Subject: CREAKING NOISE FROM FRONT SHOCK ABSORBER WHEN GOING OVER BUMPS	Bulletin No.: 02-014/18
	Last Issued: 09/04/2018

APPLICABLE MODEL(S)/VINS

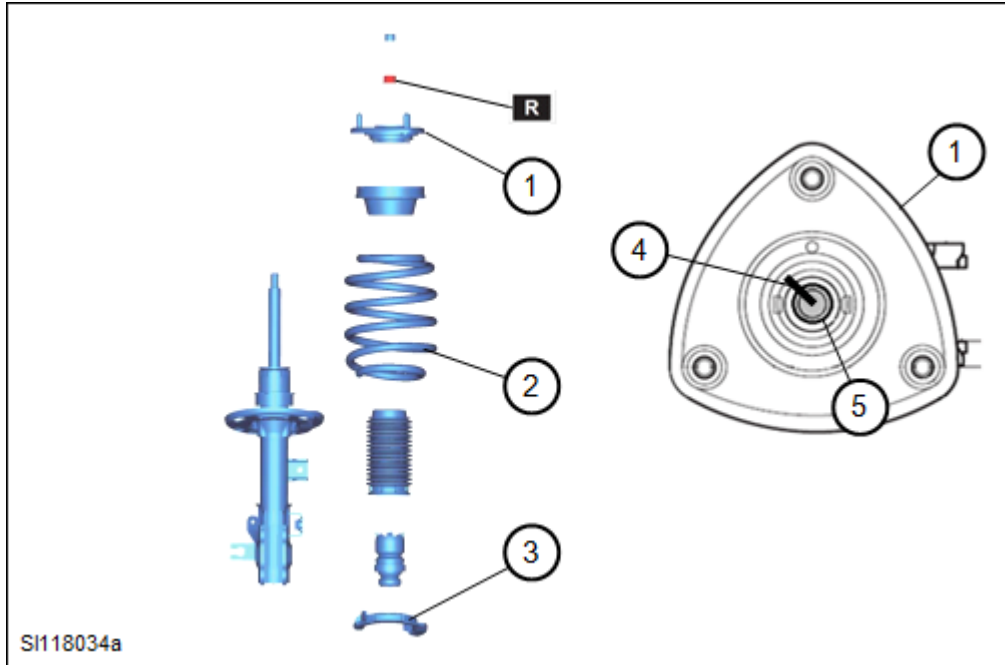
Some vehicles may experience a creaking noise from the front shock absorber when going over bumps. Upon inspection, the coil spring is found to be broken at the lower part without any trace of an accident. It may be found during maintenance or service opportunity without customer complaints. Mud and sand caught between the coil spring and the lower spring seat causes paint damage on the coil spring, resulting in rust holes and uneven force application. To correct this issue, the shape of the lower spring seat has been modified.

1. Verify customer concern.
2. Replace the broken coil spring (2) with a new one and the affected side spring seat (3) with a modified one according to the instruction on MGSS (FRONT SHOCK ABSORBER AND COIL SPRING DISASSEMBLY/ASSEMBLY).

Put a position mark (4) on the mounting rubber (1) and piston rod (5) before removing the mounting rubber from the shock absorber assembly so the mounting rubber can be installed back in the original position. If this has been done, it is not necessary to adjust the front wheel alignment because the front shock absorber and the mounting rubber are not replaced.
